CROSSROADS MIXED USE FILING NO. 2

CONSTRUCTION PLANS

V4_CDs Comments.pdf Markup Summary

CROSSROADS MIXED USE FILING NO.2
SIGNAGE & STRIPING PLANS
 PROJECT NO. 18-004
 DATE: 07/26/2023
 SCALE: HORIZONTAL: 1"=40'
 VERTICAL: 1"=5'
 DESIGNED BY: TAU
 DRAWN BY: TAU
 CHECKED BY: VAS

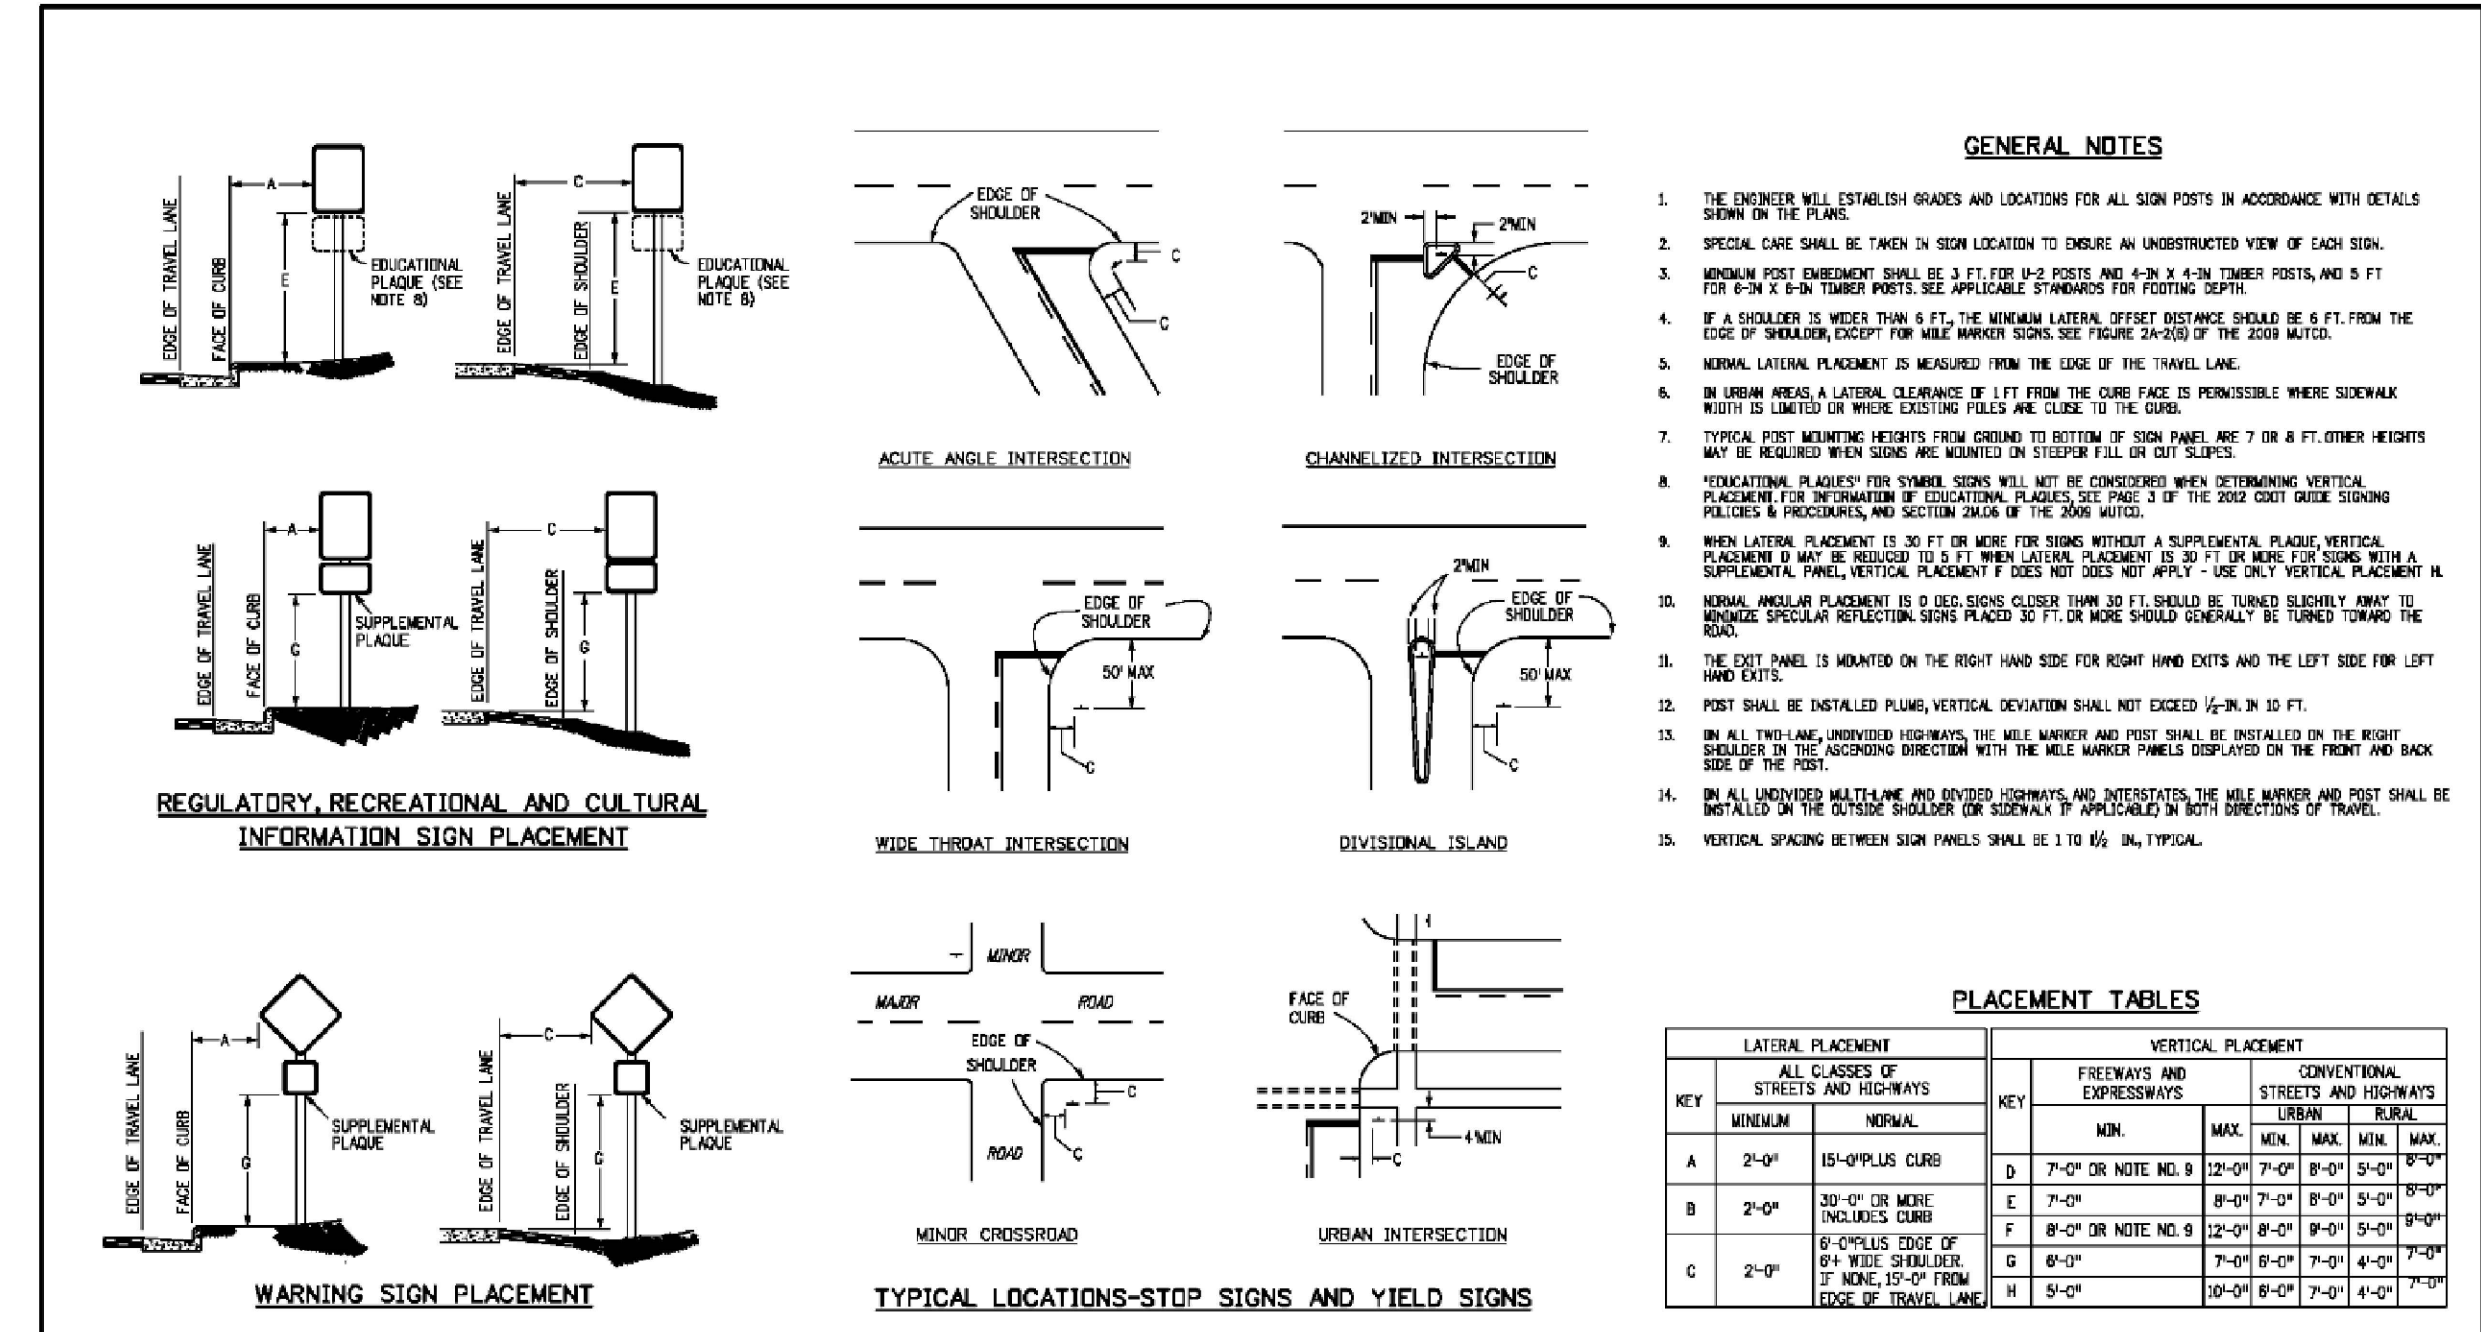
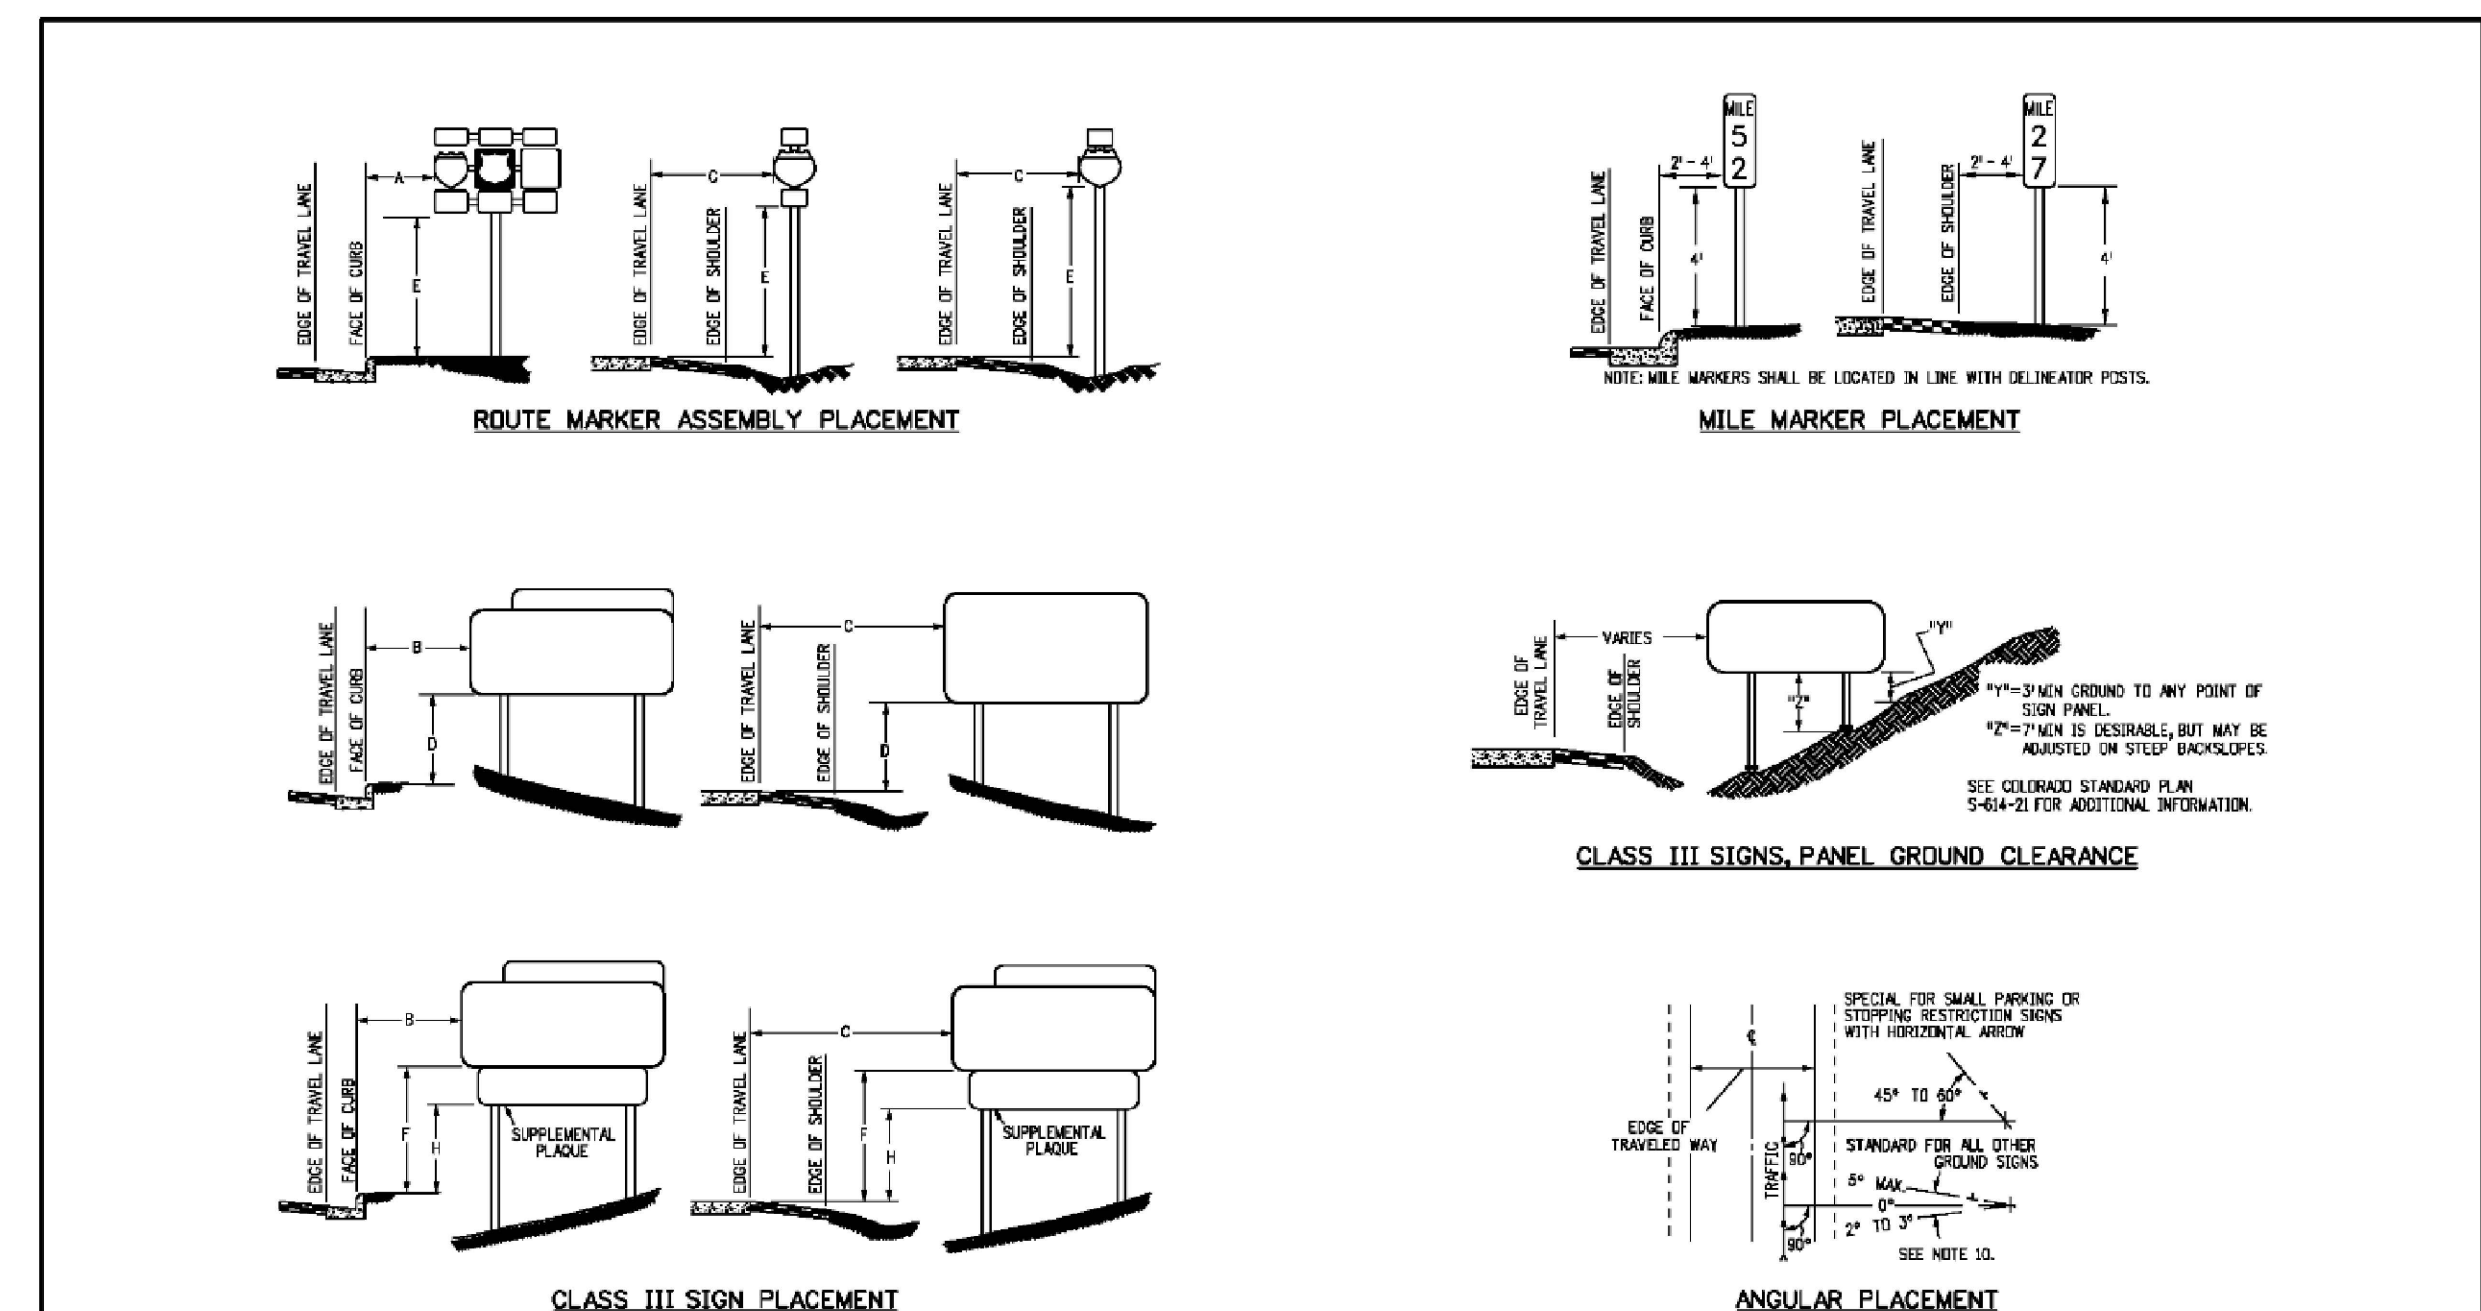
Show truncated dome for ped ramp.

EX SOUTHERN RAIL POINT

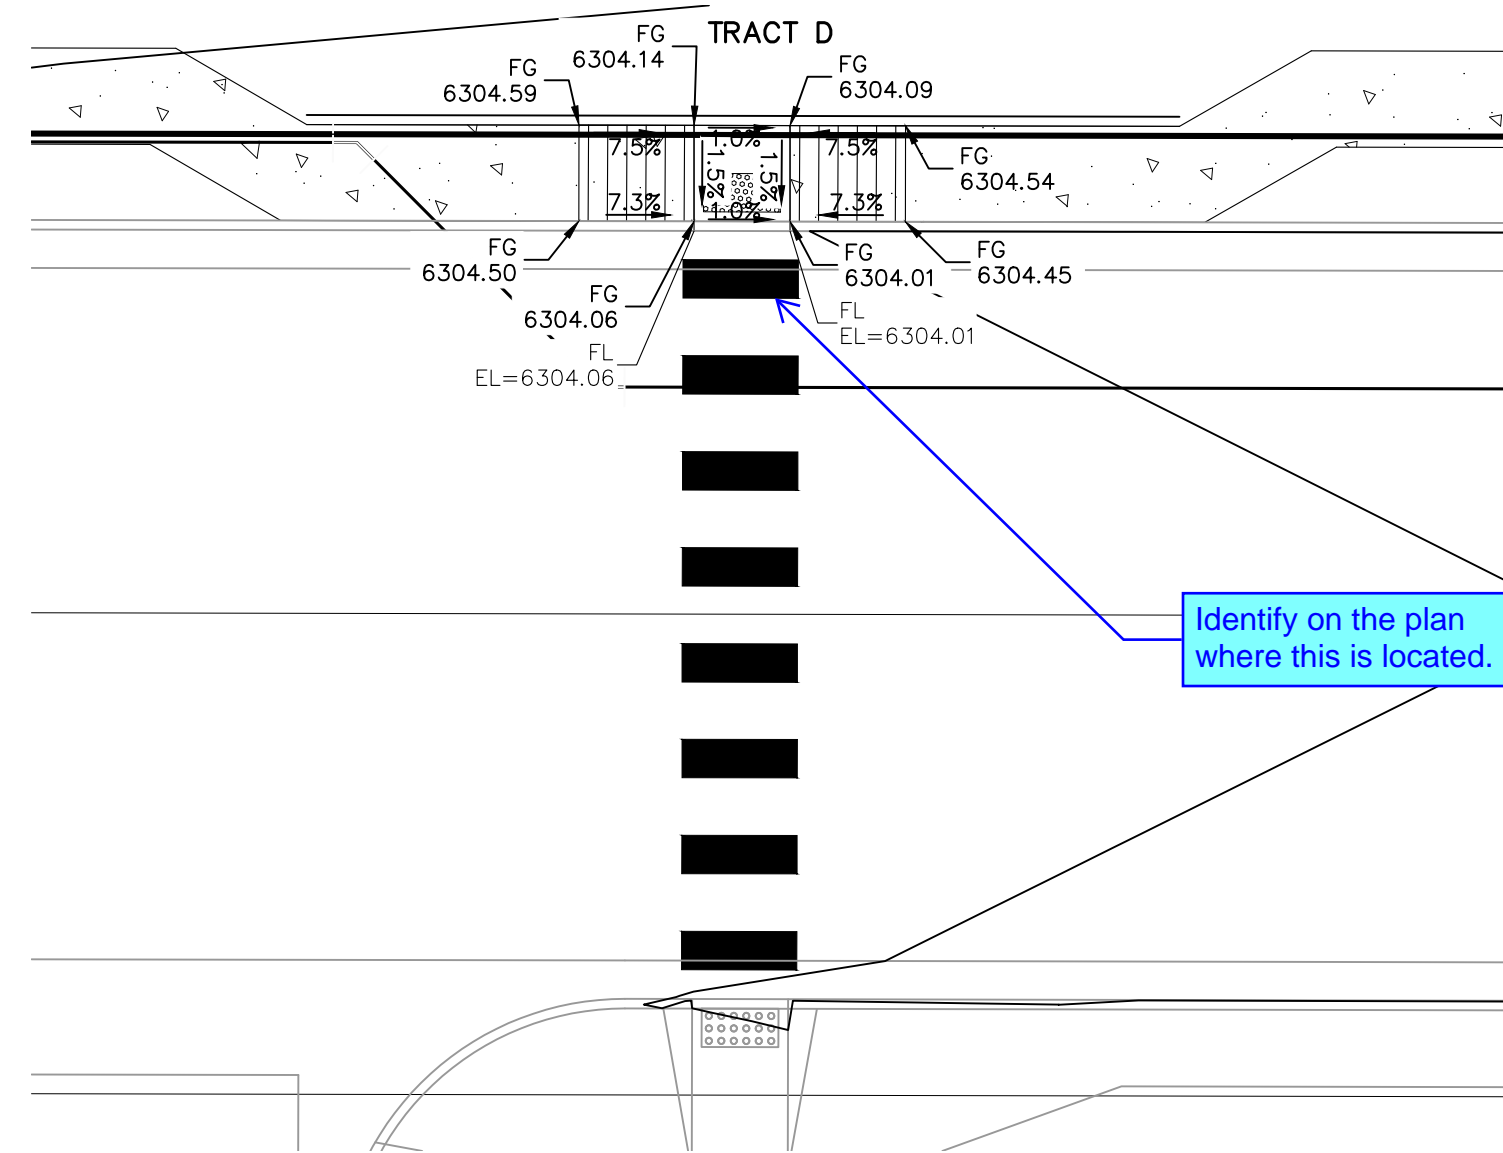
provide truncated dome

provide truncated dome
